From: Cornelis Duba <Cornelis.Duba@endeavourenergy.com.au>
Sent: Sunday, 25 October 2020 7:39 PM
To: David Schwebel
Cc: DPE CSE Information Planning Mailbox; Jeff Smith
Subject: NSW Planning, Industry & Environment Request for SEARs SSD-10272349 GPT Industrial Estate, Mamre Road, Kemps Creek
Attachments: EE Drawing 86232 OH lines minimum clearances.pdf; SW08773 Work near underground assets.pdf; SW Work near overhead power lines.pdf; ENA EMF What We Know.pdf; EE Safety Plumbing.pdf; EE Safety on the job.pdf; EE MDI0044 Easements and Property Tenure.pdf; EE Guide for Padmount Substations.pdf; EE General Restrictions OH Power Lines Apr 2020.pdf; EE FPJ 6007 Technical Review Request Aug 2019.pdf; EE FPJ 4603 Permission to Remove Service July 2007.pdf

I refer to the your below email of 22 October 2020 regarding the Request for Secretary's Environmental Assessment Requirements (SEARs) for State Significant Development SSD-10272349 for the GPT Industrial Estate being for 'Concept plan and Stage 1 DA for an industrial estate. Stage 1 comprises two warehouses, site-wide bulk earthworks and retaining walls, an internal road network, storm water works, car parking, signage and landscaping' l

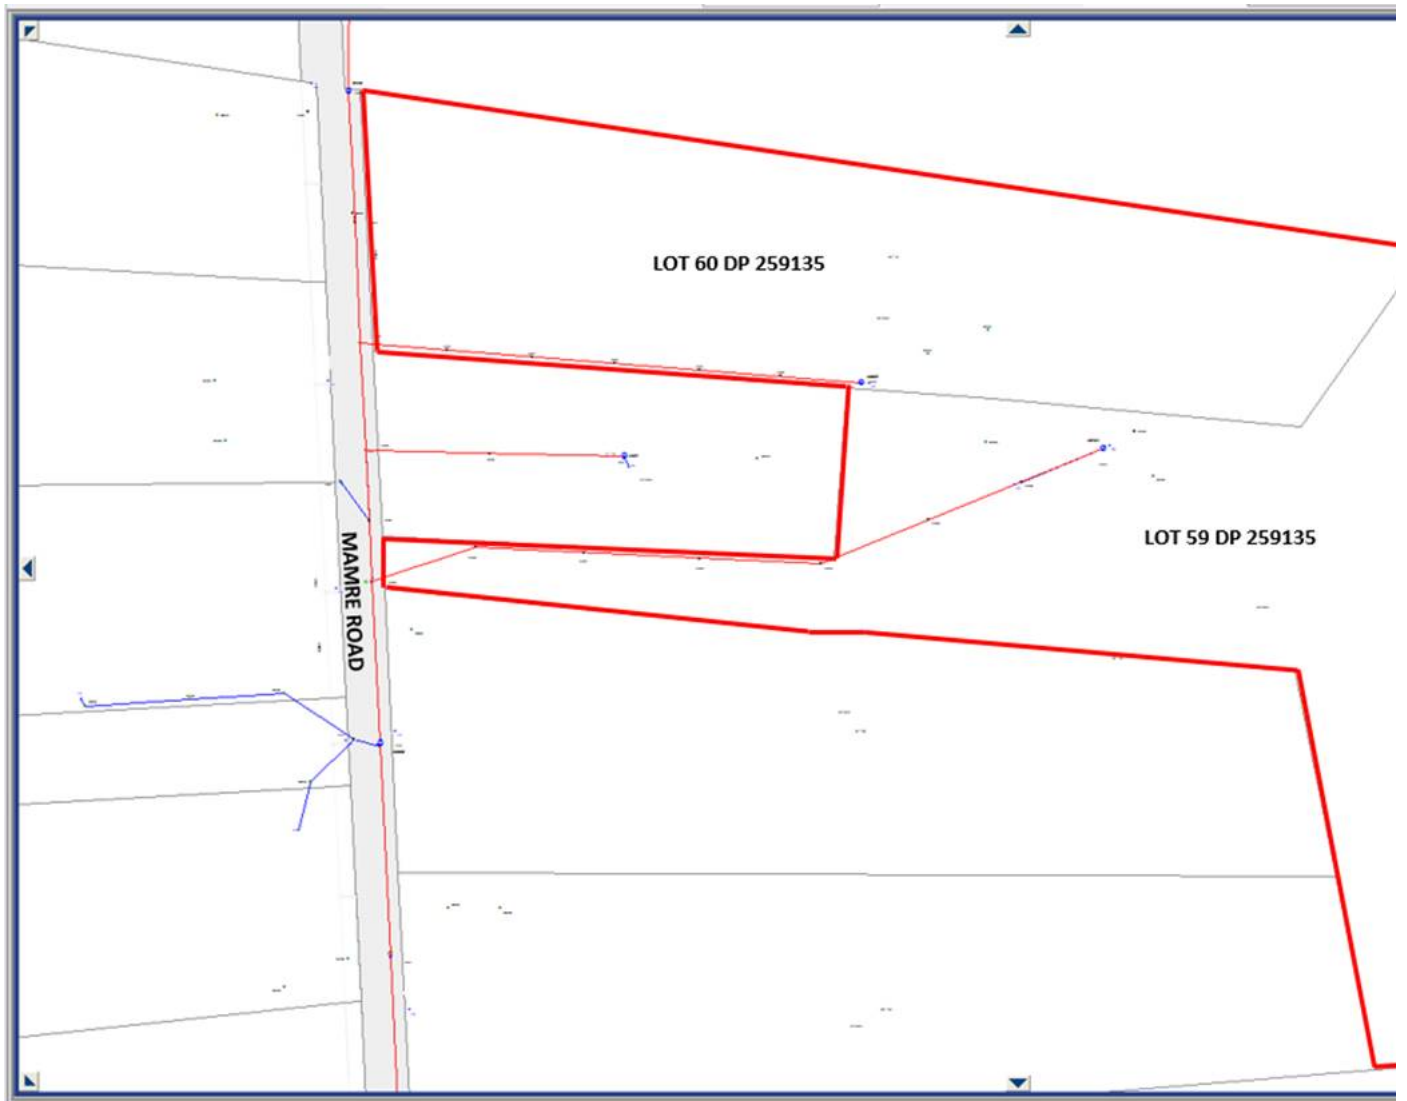
As shown in the below site plans from Endeavour Energy's G/Net master facility model (and extract from Google Maps Street View) there are:

- No easements over the site benefitting Endeavour Energy (active easements are indicated by red hatching).
- Low voltage and 11,000 volt / 11 kilovolt (kV) high voltage overhead power lines including pole mounted substation no. 8418 (indicated by the symbol ) to the road verge / roadway .
- 11 kV high voltage overhead power lines coming from poles on the road verge to pole mounted substations 18064 and 16421 on the site from which there are low voltage overhead service conductors going to the customer connection point for the existing dwellings / premises on the site (which are likely to become redundant assets if the proposed development proceeds).

In regard to the 11 kV high voltage overhead power lines traversing the site, although not held under easement (and they only service the sites on which they are located) are protected assets and deemed to be lawful for all purposes under Section 53 'Protection of certain electricity works' of the Electricity Supply Act 1995 (NSW). Essentially this means the owner or occupier of the land cannot take any action in relation to the presence in, on or over the land of electricity works ie. the electricity infrastructure cannot be removed to rectify the encroachment. These protected assets are managed as if an easement is in place – please refer the below point 'Easement Management / Network Access'.
